CITY PLANNING COMMISSION

- APPLICATION:
1. Variance to locate a portion of required four-foot planter in public rights-of-way (Stockton Boulevard and Fruitridge Road) (Sec. 6-D-5) (P83-241B)
 2. Variance to reduce required four-foot planter to two and one-half feet (Fruitridge Road) (Sec. 6-D-5) (WITHDRAWN)

PROPOSAL: To develop a savings and loan in the C-4 zone.

CPC ITEM NO. 23

SITE PLAN & DETAILS

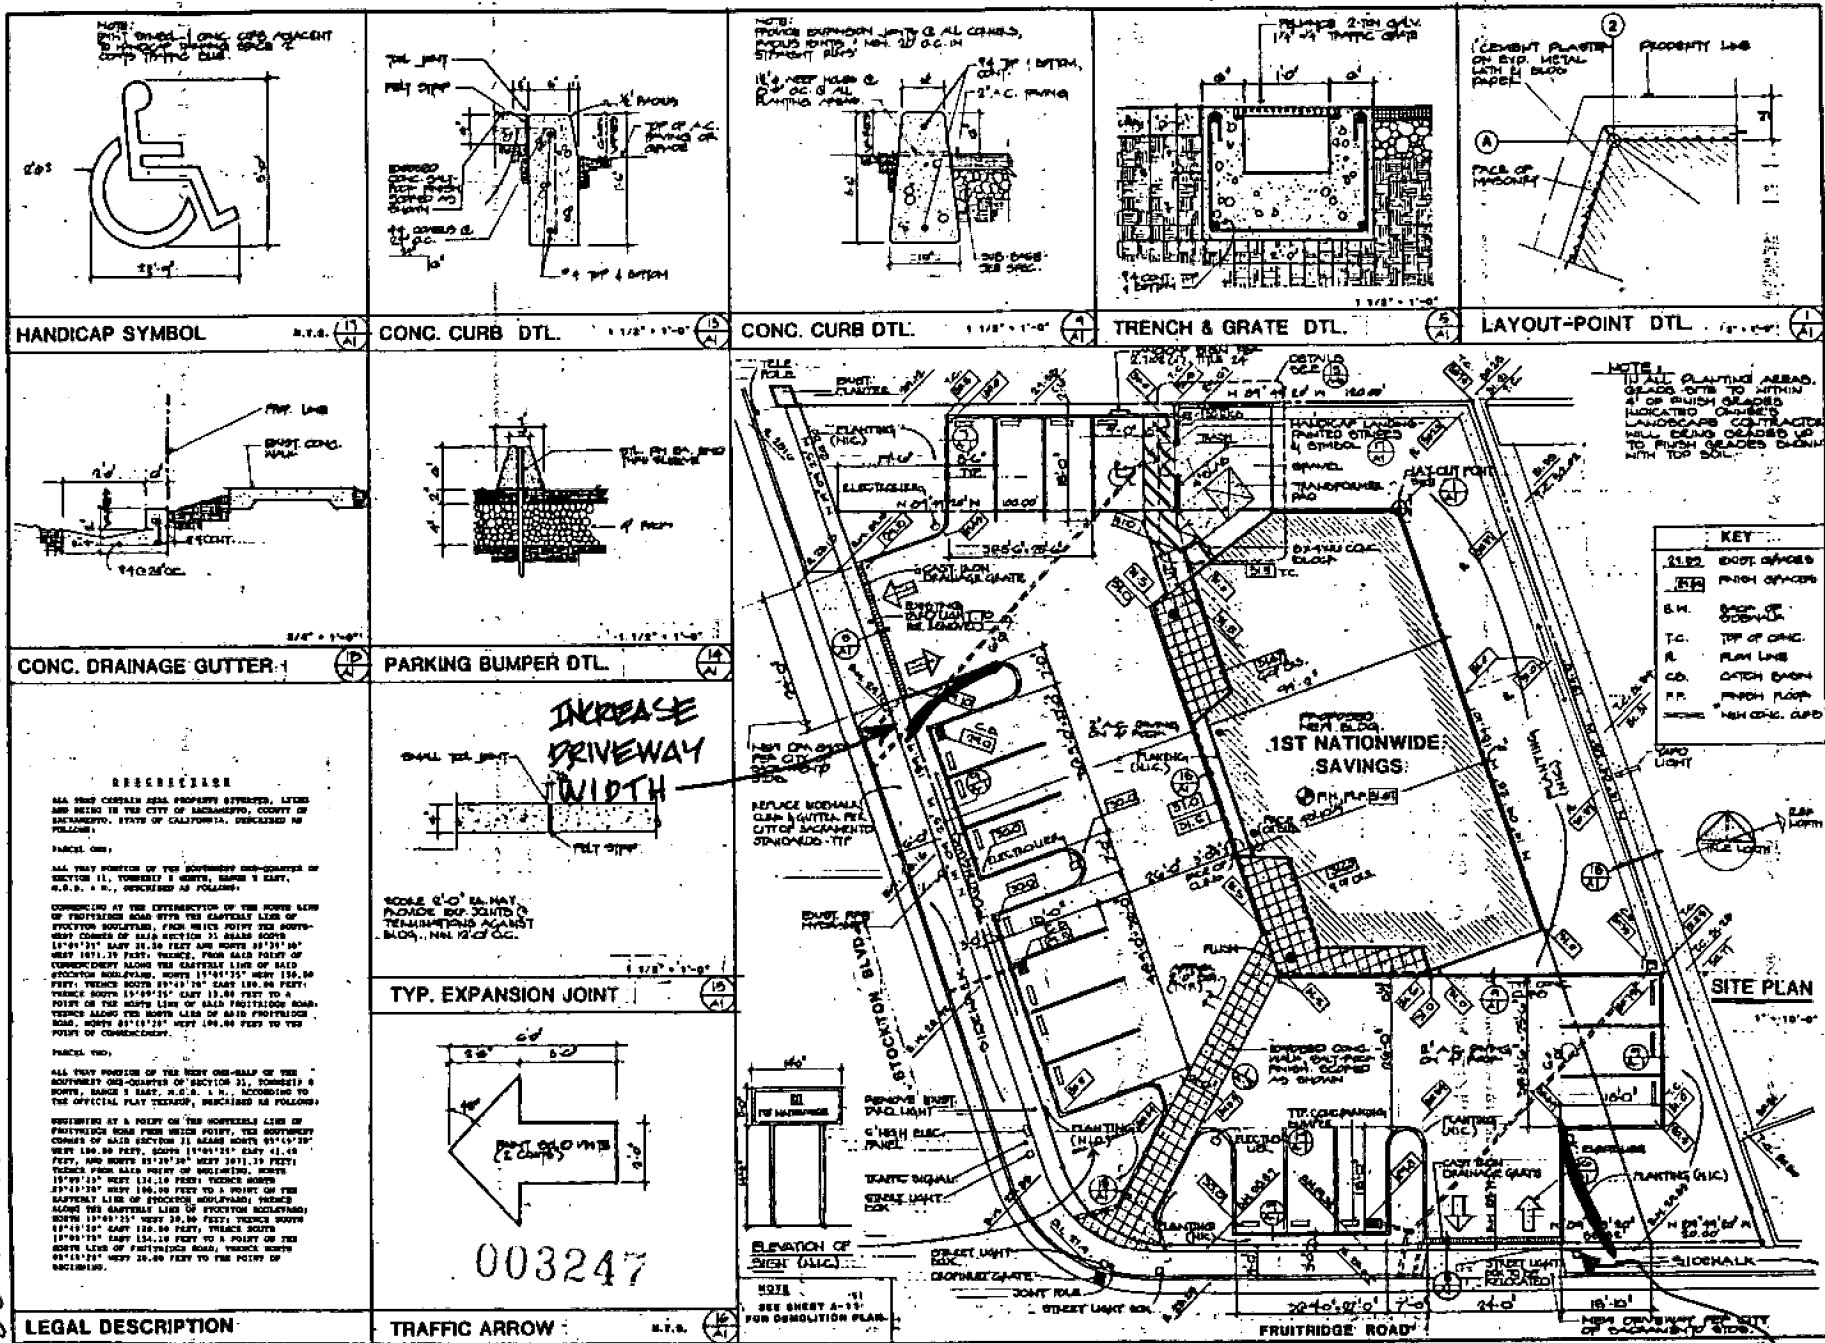
1. The project site is comprised of two legal parcels under different ownerships. As such, the site design options are somewhat limited. An 18 foot strip along the northerly and easterly property lines accommodates surplus parking (including the handicap space), the trash enclosure, and a transformer. The building will be butted against this parcel and parking will be provided in the remaining area abutting the street frontages (see Exhibit 'A').

2. Staff has no objection to the use of the public right-of-way for satisfaction of required planting. Such use has been approved elsewhere in the past. Staff would specify however that the front two feet of each parking stall be incorporated into the landscaping planter in order to increase the width of planter areas. This would allow the six-inch curb around the planter area to act as a wheel stop.

3. The applicant requested a variance to allow the planter strip along Fruitridge Road to be two and one-half feet in width. Staff informed the applicant that the variance would not be needed if the three parking spaces be designed as compact spaces. This would reduce the stall depth and maneuvering area by three feet. The applicant agreed with staff; therefore, the variance for the two and one-half foot wide planter has been withdrawn.

4. The applicant's plans do not show the required six-inch raised concrete curb for the planters where they abut the back of the public sidewalks. The Zoning Ordinance requires that the planters be completely surrounded by the raised curb.

5. The Traffic Engineering Division indicated the need for the following changes:
 - a. Increase the width of the Stockton Boulevard curb cut from 24 feet to 35 feet by flaring the south edge of the driveway. (See Exhibit 'A');

- b. Increase the width of the Fruitridge Road curb cut from 24 feet to between 30 - 35 feet by flaring the east edge of the driveway (See Exhibit 'A').

INCREASE DRIVEWAY WIDTH PER TRAFFIC ENGINEER

- a. The three parking spaces abutting the Fruitridge Road right-of-way shall be compact spaces with 16 feet of depth, and the maneuvering depth shall be 25 feet;
- b. The two-foot overhang area of parking spaces shall be incorporated into the abutting landscaped planters;
- c. The applicant shall obtain an encroachment permit from the City Engineer;
- d. A detailed landscape and irrigation plan and the 50 percent shading plan shall be submitted for the review and approval of staff prior to issuance of building permits.
